NL-06-1832

Joseph M. Farley Nuclear Plant – Unit 1  
Vogtle Electric Generating Plant – Units 1 & 2  
Response to NRC Request for Additional Information Regarding  
Inservice Inspection Alternatives for Reactor Pressure Vessel Examinations

**SNC Response to NRC RAI Related to Request ISI-GEN-ALT-06-02**

**FIGURE 1**  
(Illustrative Purposes Only - not to scale)

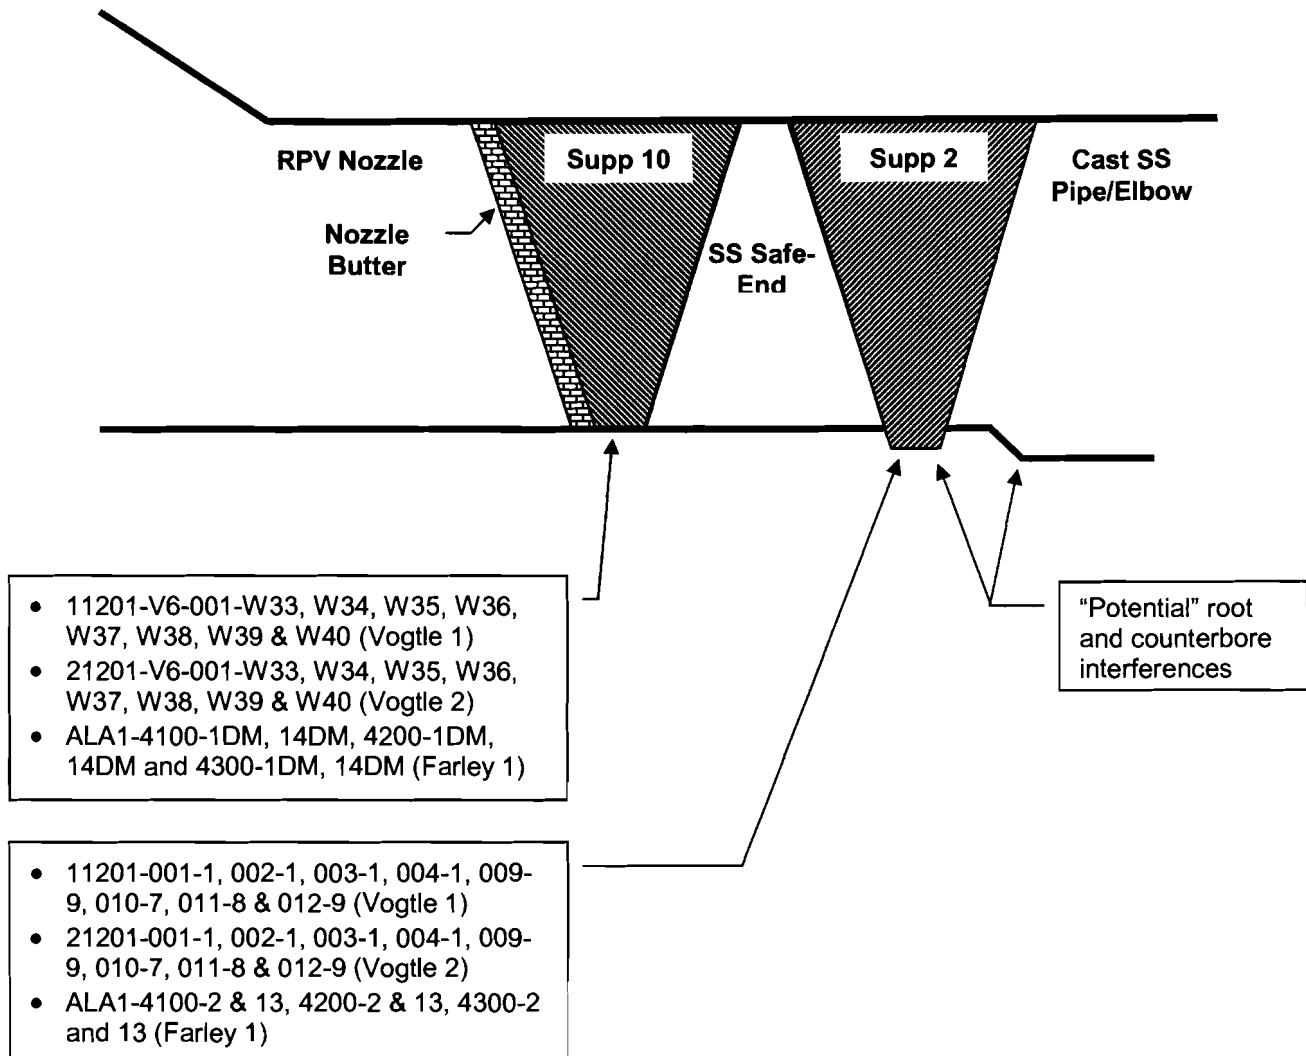
**Explain why the ASME Code RMS value is not achievable for the selected vendor.**

The difficulty of achieving the required 0.125-inch RMS error factor results from ID geometry interferences (e.g., root, counterbore). To accurately size thru-wall indications, the transducers ability to scan over the flaw must not be impeded by these interferences. The qualification mockups for both Supplements 2 and 10 were fabricated from field supplied data, representing the expected worse case scenarios. In most cases, the austenitic joint (Supplement 2) is field welded with root and counterbore restrictions occurring. For most 3 and 4 loop Westinghouse designs, the dissimilar metal (DSM) joint (Supplement 10) has been shop machined, resulting in little or no geometric interferences. Both Farley and Vogtle Supplement 10 configurations are expected to be unimpeded. Therefore, it is expected that the proposed alternative 0.189-inch RMS error factor would be a conservative alternative compared to the qualification specimens. Part of the examination process for remote mechanized inspections is the gathering of profile data. This information is used for coverage determinations. The data is also being collected to ensure qualification mockups represent the full alignment of field conditions within the industry. Surface scan access and/or cast material difficulties restrict the examinations for the Farley and Vogtle configurations from the outside diameter (OD). A figure is provided for illustrative purposes.
